February 17, 2017

**ADDENDUM #2
8TH STREET ROAD IMPROVEMENT PROJECT
CITY OF CHATTANOOGA CONTRACT # T-16-014-201**

DATE: 01/13/17
DRAWN BY: DAB
CHECKED BY: MAP
PROJ. NUMBER: 15-170
SHEET NUMBER: **C-11**

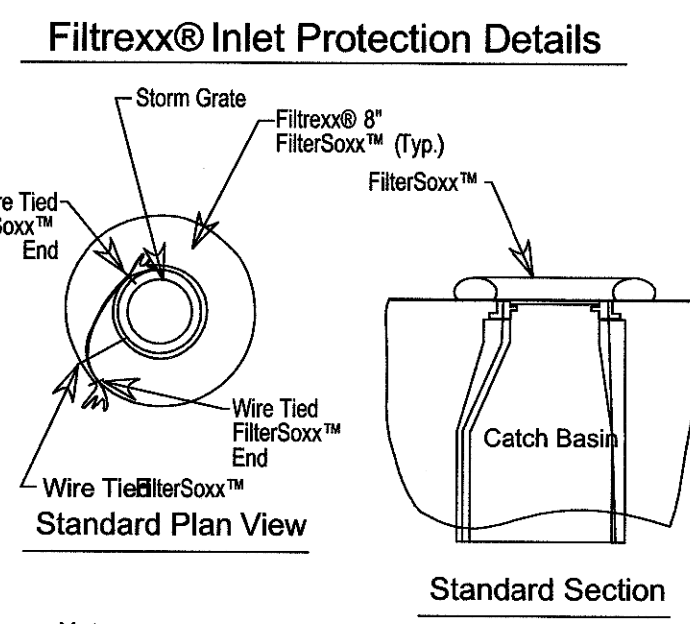
Item #16. Replace Sheet C-11 – Erosion Control Plan (Originally dated 01/13/17) – with attached Sheet C-11 – Erosion Control Plan (Revision #1 dated 02/16/17). Note the revisions consist of:

- Reflecting erosion controls to be implemented along 8th Street.

DATE: 01/13/17
DRAWN BY: DAB
CHECKED BY: MAP
PROJ. NUMBER: 15-170
SHEET NUMBER: **C-12**

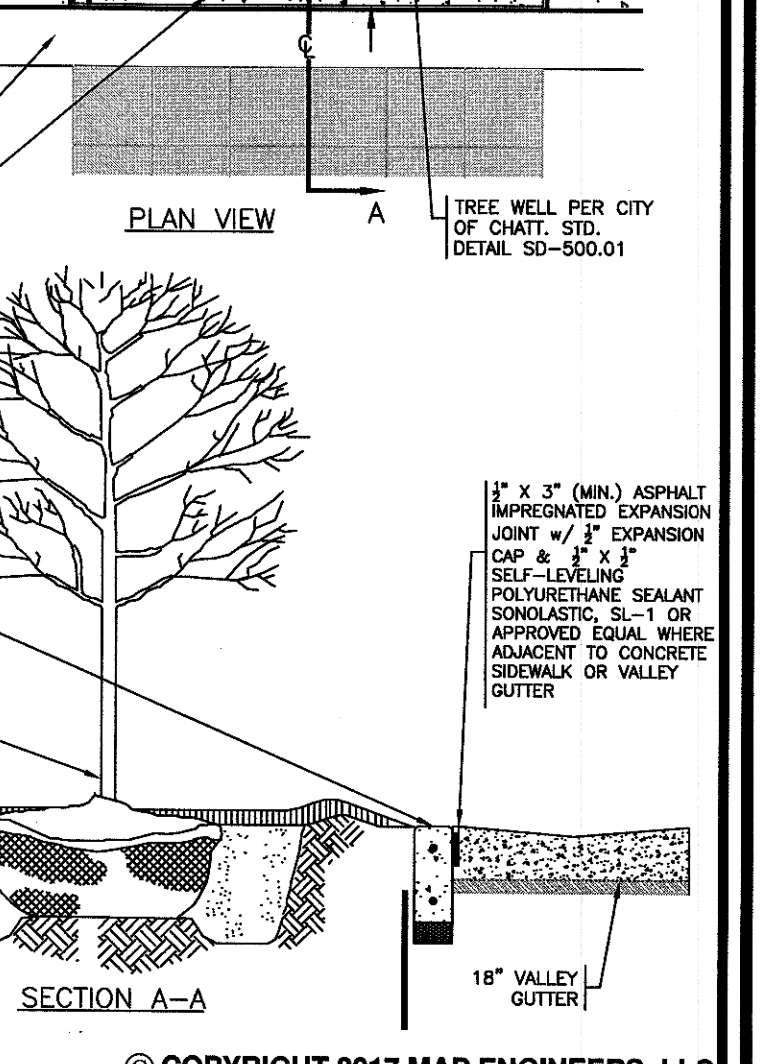
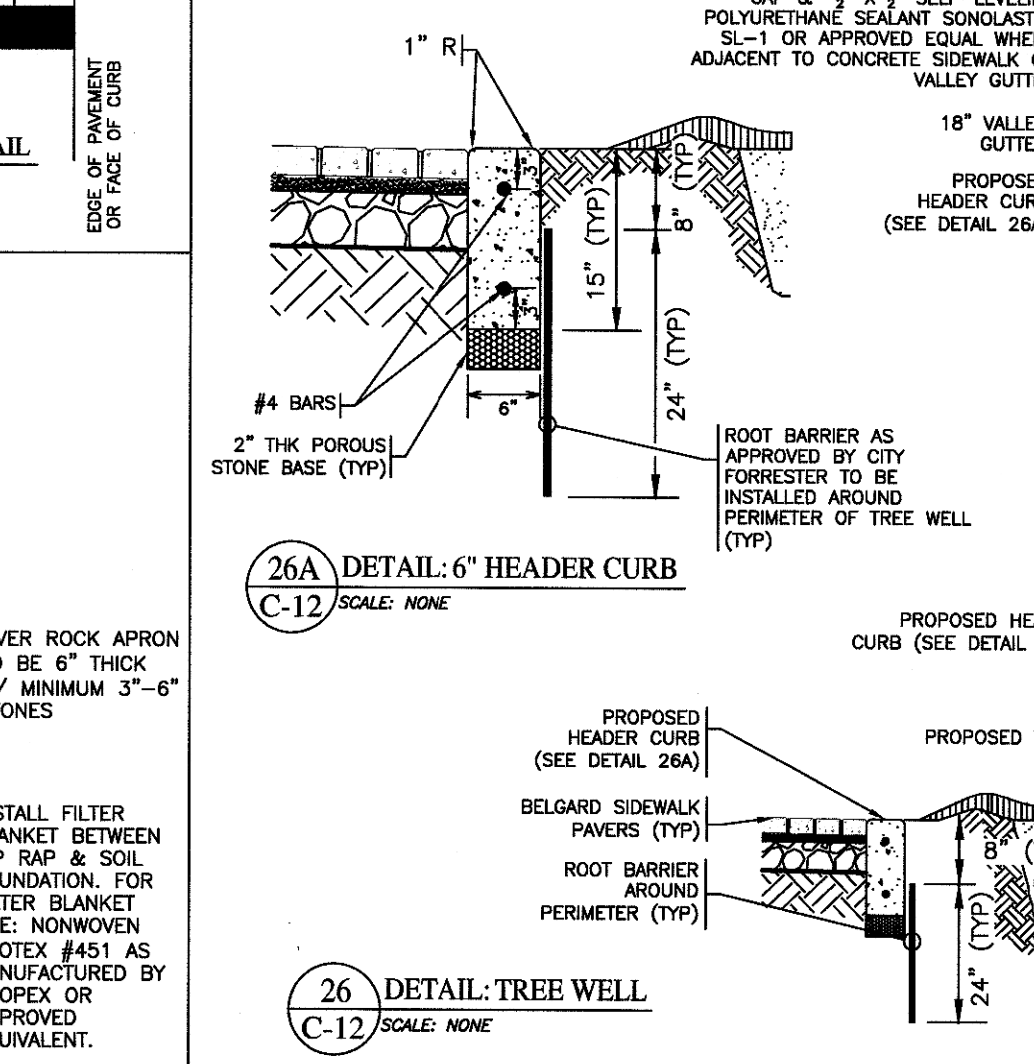
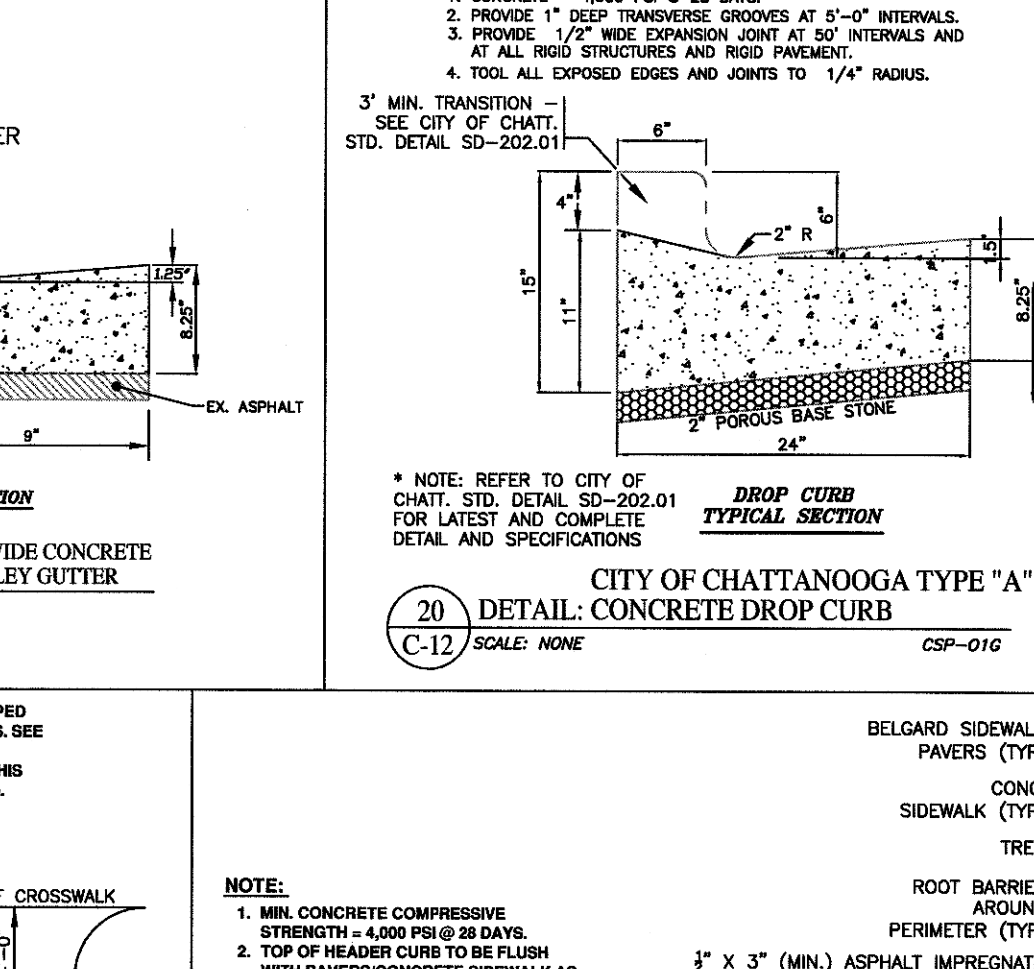
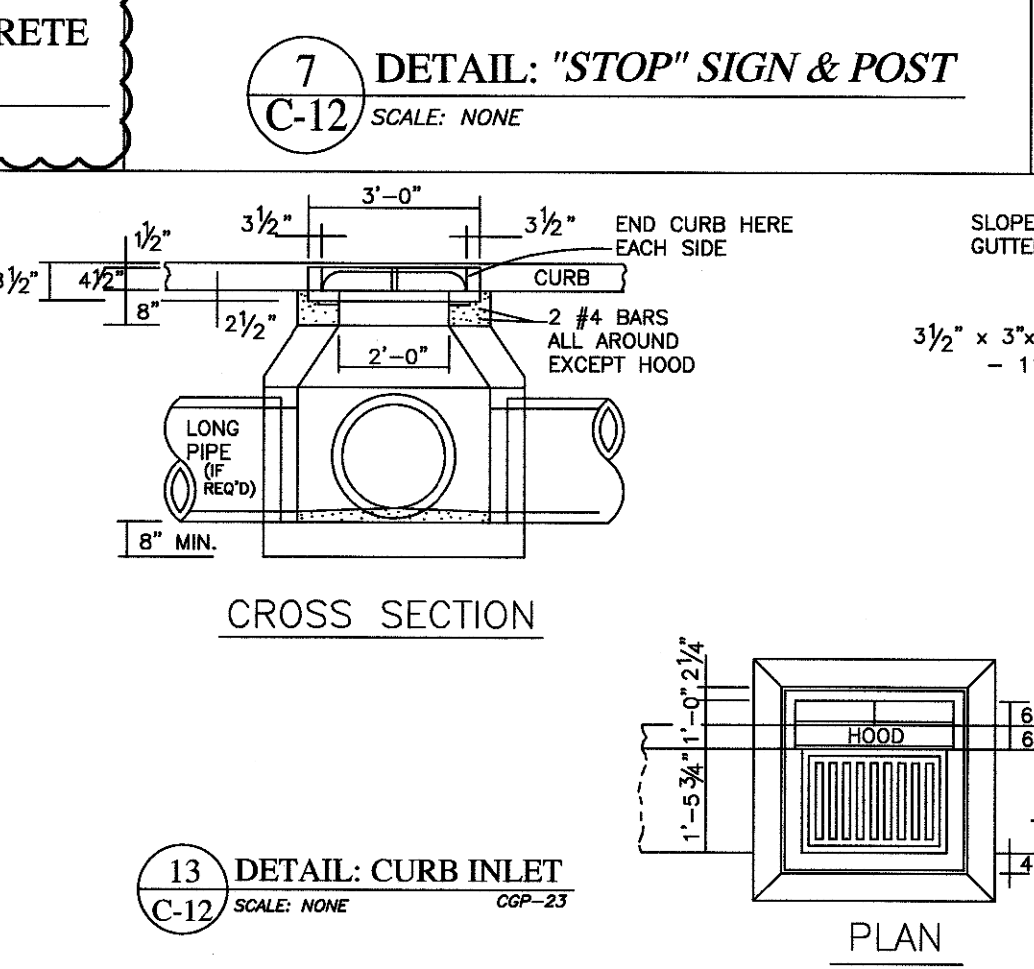
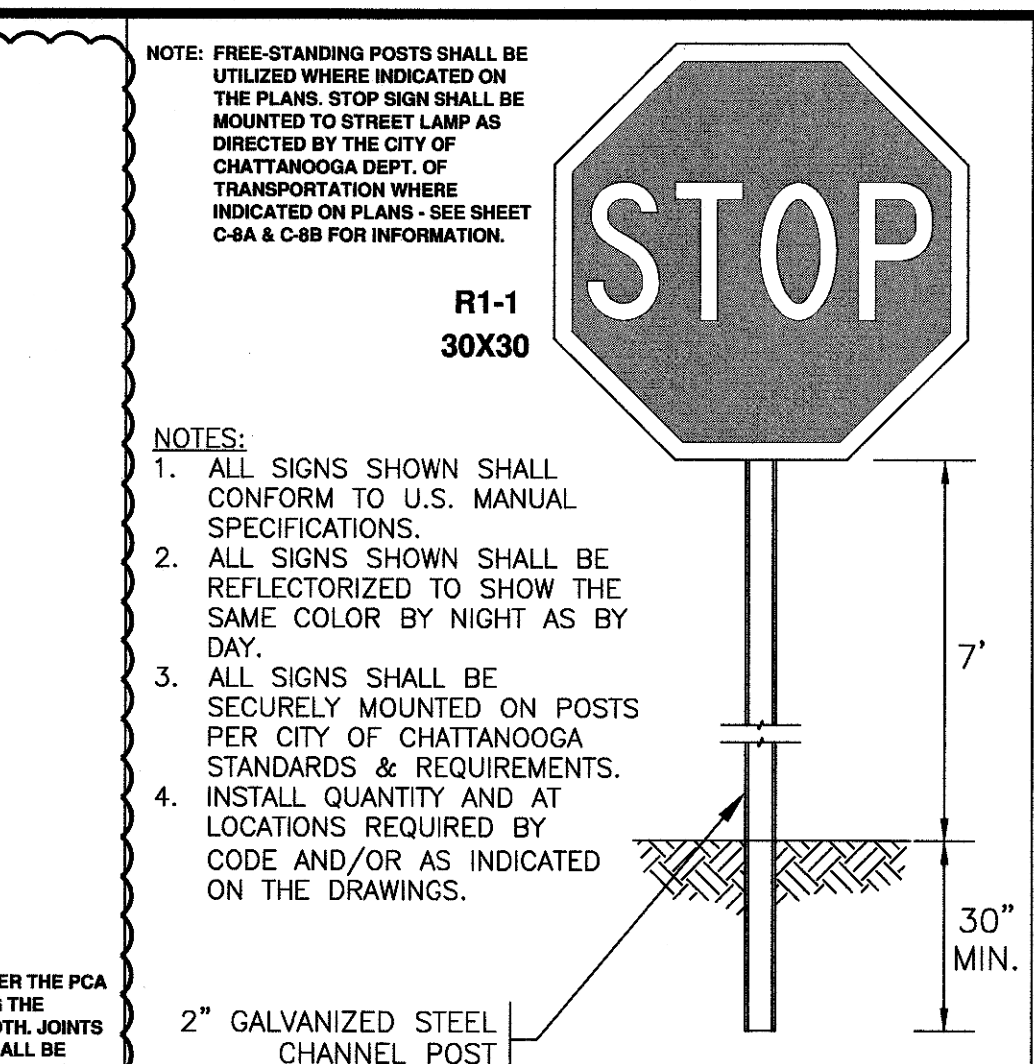
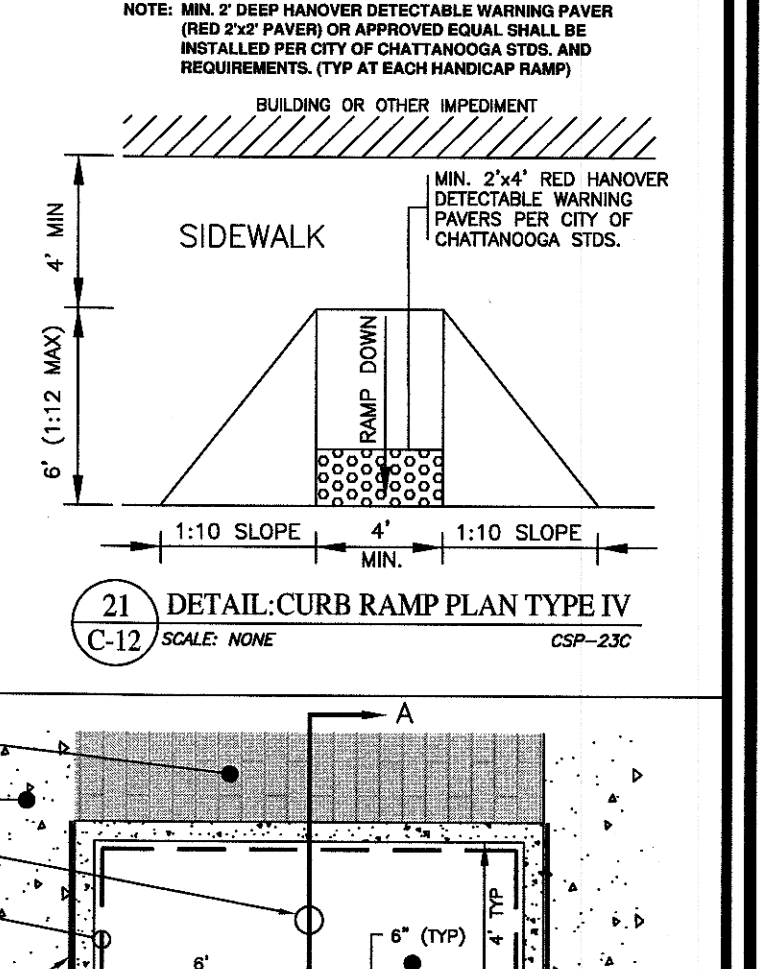
- Item #1.** Clarification: Details #4, #5 & #6 on Sheet C-12 reflect the full-depth concrete pavement specifications to be encountered on the 8th Street project. These details provide the concrete thicknesses based upon the underlying pavement material encountered after milling/demolition activities have been completed. While field conditions may cause variations in the pavement thicknesses based upon the above reference details, for purposes of providing a lump sum amount for the concrete work, please use the following pavement recommendations:

Item #17. Replace Sheet C-12 – Site Details (Originally dated 01/13/17) – with attached Sheet C-12 – Site Details (Revision #2 dated 02/16/17). Note the revisions consist of:

- Revising details #4, #5 & #6 to reflect the concrete pavement to be installed per City Code Section 32-287.

- Concrete Paving for On-Street Parking with Integral Coloring:
 - 5" thick concrete pavement including integral coloring & tooled joint scoring, complete-in-place, per City of Chattanooga City Code Section 32-287 as required and/or as specified.

- Concrete Paving for Roadway with Integral Coloring:
 - 6" thick concrete pavement including integral coloring & tooled joint scoring, complete-in-place, per City of Chattanooga City Code Section 32-287 as required and/or as specified.

- Concrete Paving for Intersections with Integral Coloring & Stamping:
 - 10" thick concrete pavement including integral coloring, stamping & tooled joint scoring, complete-in-place, per City of Chattanooga City Code Section 32-287 as required and/or as specified.
